UNITED STATES PATENT AND TRADEMARK OFFICE

APPLICATION NO.	FILING DATE	FIRST NAMED INVENTOR	ATTORNEY DOCKET NO.	CONFIRMATION NO.
10/642,634	08/19/2003	Lakdas Nanayakkara	1070.16.1	3782
7590	08/13/2004			
MELVIN K. SILVERMAN & ASSOCS., P.C. SUITE 500 500 WEST CYPRESS CREEK ROAD FORT LAUDERDALE, FL 33309			EXAMINER CHAPMAN, JEANETTE E	
			ART UNIT	PAPER NUMBER
			3635

Office Action Summary

PATENT COPY WITH
ANNOTATIONS

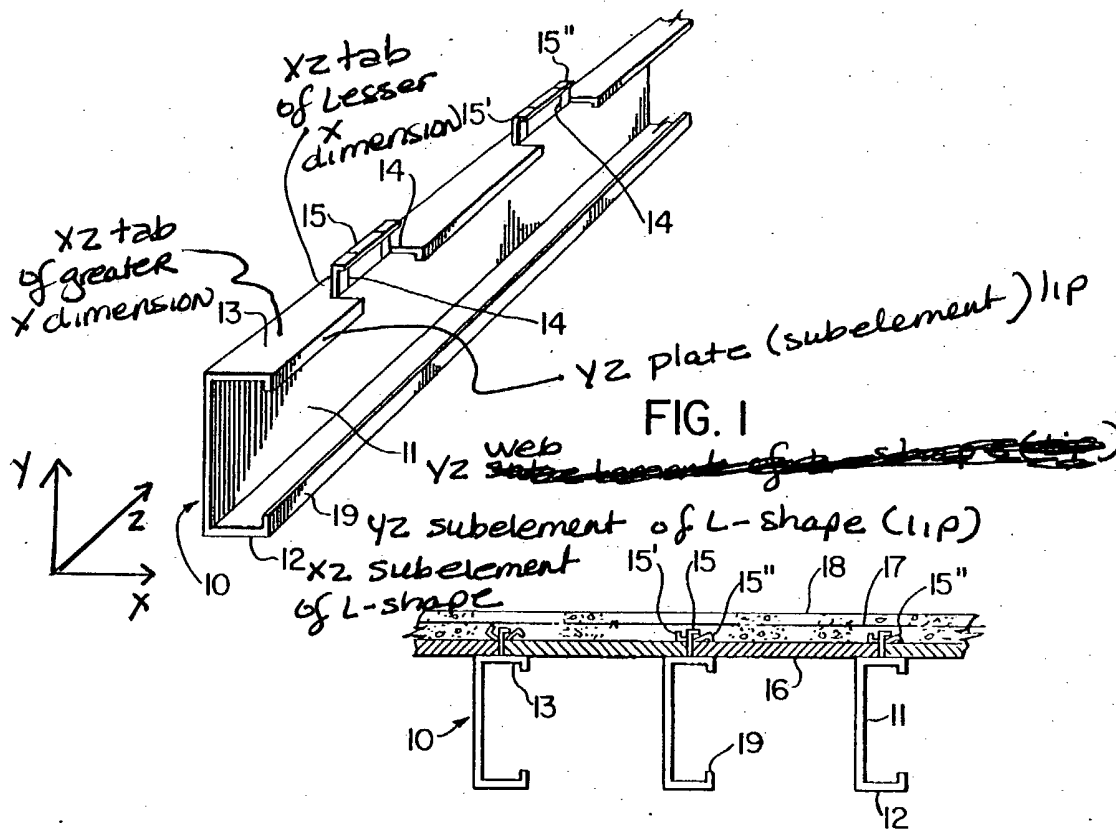
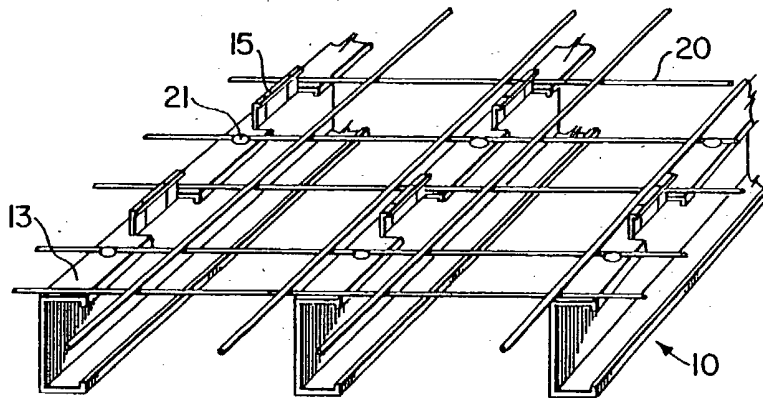
Claims 1-5, 7-10 and 12 are rejected under 35 U.S.C. 102(b) as being anticipated by Schliger (4885884). See annotations on patent copy where included are the x,y,z coordinate system and labels added for clarity.

Figure 11 shows a concrete slab 37 into which substantially all of the greater dimension xz plane tabs of said series thereof are embedded. It is not clear if this embedding is prior to the hardening of the slab 37; this choice has been considered a

matter of choice in the making of the stud element construction system. Such a choice is depended on the method of making techniques available to one of ordinary skill in the art. All of the structural limitations have been shown, and it is clear that embedding the tabs prior to hardening is easier than trying to embed the tabs forcefully after hardening.
